# T ECHNICAL INFORMATION

- Subject** ▶ Change of Bumper
- For Models** ▶ 6905H
- Country** ▶ All countries
- Description** ▶ As illustrated below, Bumper has been changed for standardization.  
The new Bumper is identical with that of Model SI100.

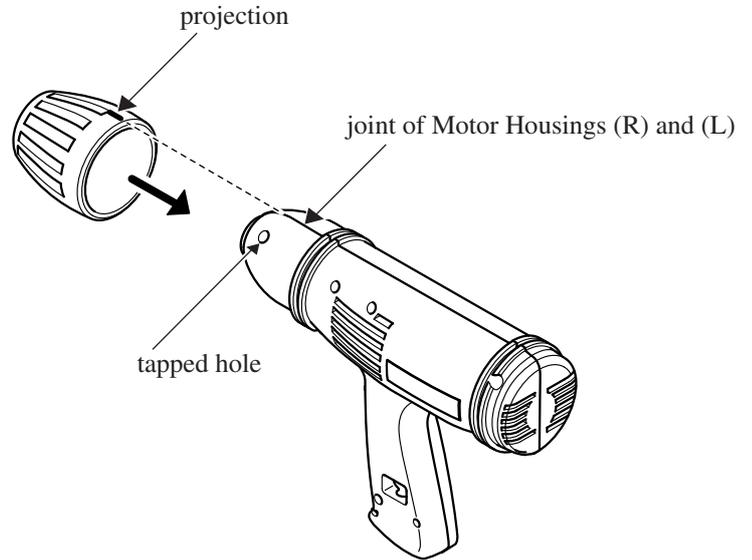
▶ Current	▶ New
Bumper (Part No.421375-8)	Bumper (Part No.421747-7)
View from the Motor Housing side	View from the Motor Housing side
	 <p style="text-align: center;">Four bosses have been added on the inner surface of Bumper.</p>

Aligning the projection on Bumper with the joint of Motor Housings (R) and (L) as illustrated on right, push Bumper until its inner bosses are securely put in the tapped holes of Motor Housing.

Item No.	Current part	Q'ty	I/C	New part	Q'ty	Note
020	Bumper 421375-8	1	Yes	Bumper 421747-7	1
